DAVIS-BESSE NUCLEAR POWER STATION UNIT NO. 1		0
INSERVICE INSPECTION DIAGRAM STEAM GENERATOR SECONDARY SYSTEM		
DRAWING NO.		REV.
IS1D2-007A		5

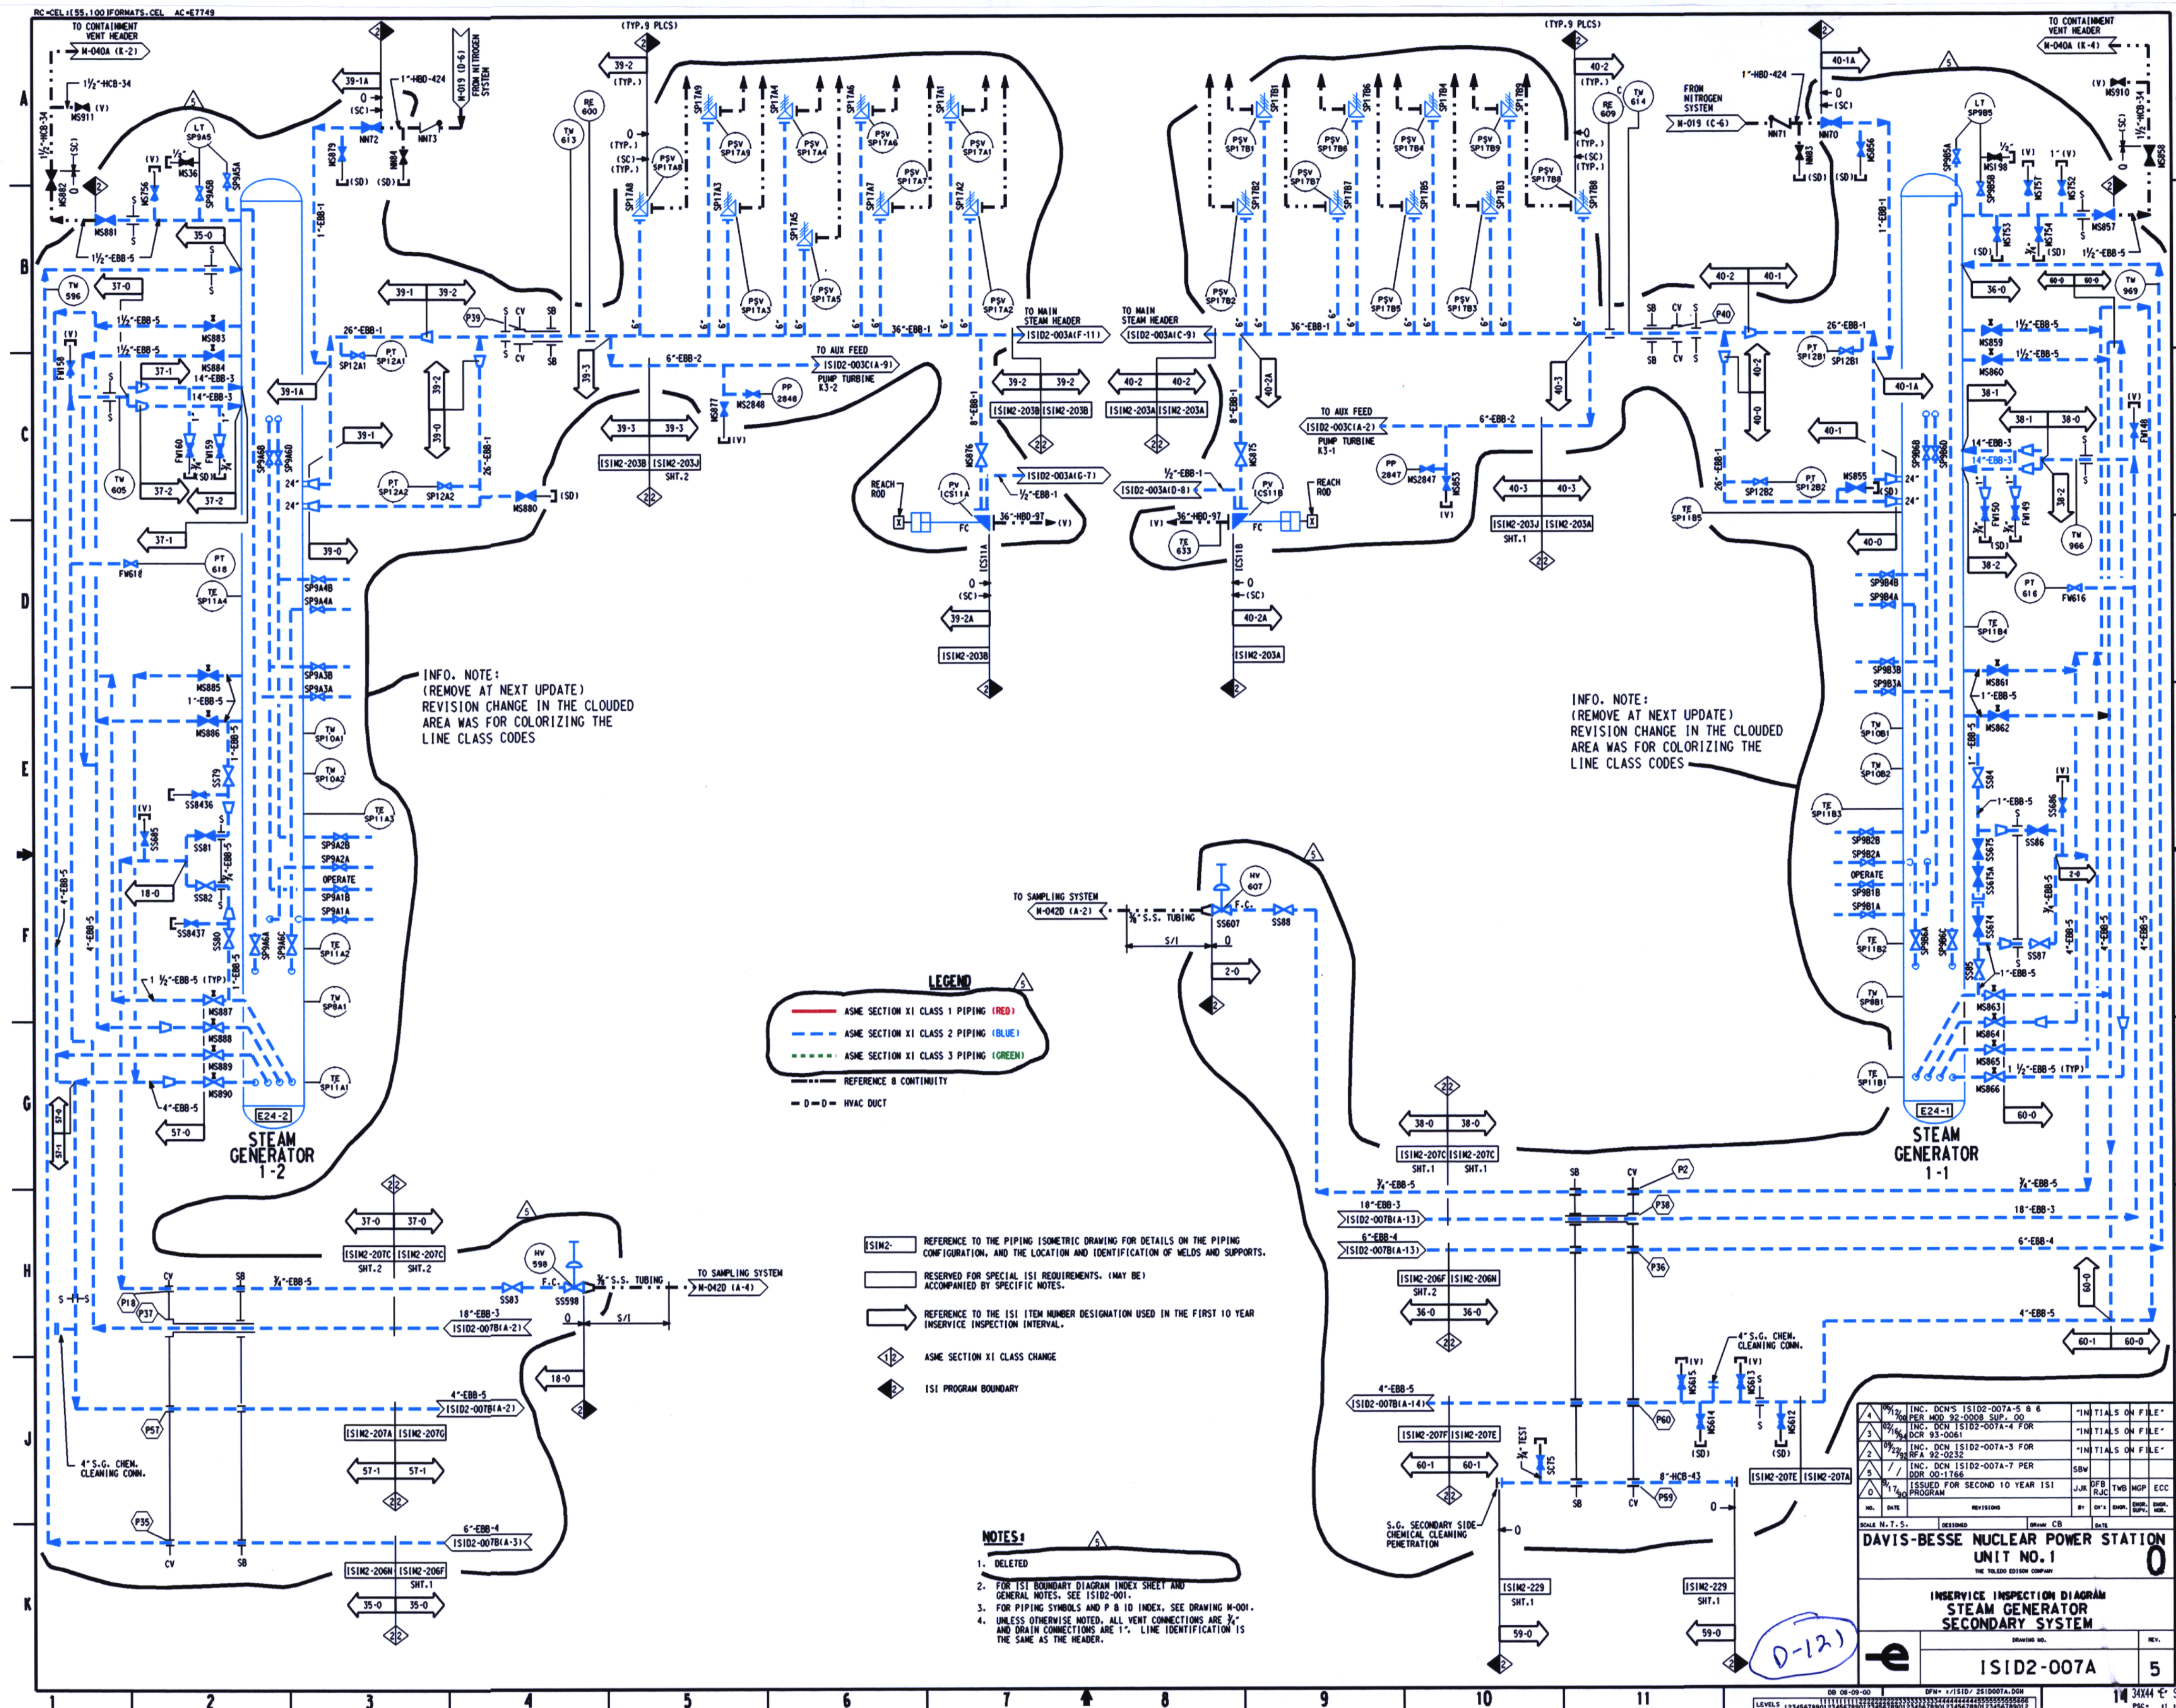
INFO. NOTE:
(REMOVE AT NEXT UPDATE)
REVISION CHANGE IN THE CLOUDED
AREA WAS FOR COLORIZING THE
LINE CLASS CODES

INFO. NOTE:
(REMOVE AT NEXT UPDATE)
REVISION CHANGE IN THE CLOUDED
AREA WAS FOR COLORIZING THE
LINE CLASS CODES
